MIKE TURTUR BIKEWAY UPGRADE

Community Feedback Questions and Responses 5th June 2020

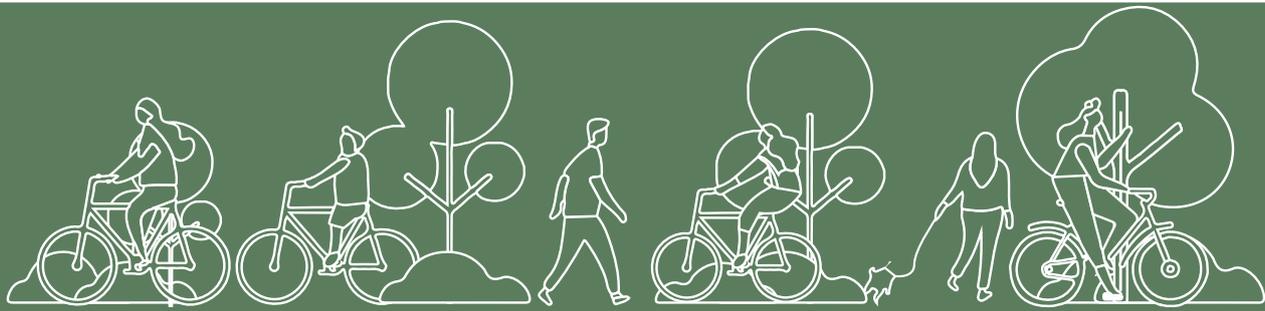
Is DPTI undertaking consultation?

- The project is a partnership between DPTI and the City of Unley and consultation is being undertaken by the City of Unley.
- All consultation feedback will be considered by DPTI and the City of Unley to inform the final design outcomes.
- In terms of construction works, DPTI will be undertaking the civil construction works and Council will undertake the landscape works.
- Notification with details of the timing of works and any traffic management requirements will occur prior to commencement.

Please note the consultation timeframe has been extended to the 15th of June to provide more opportunity for community feedback.
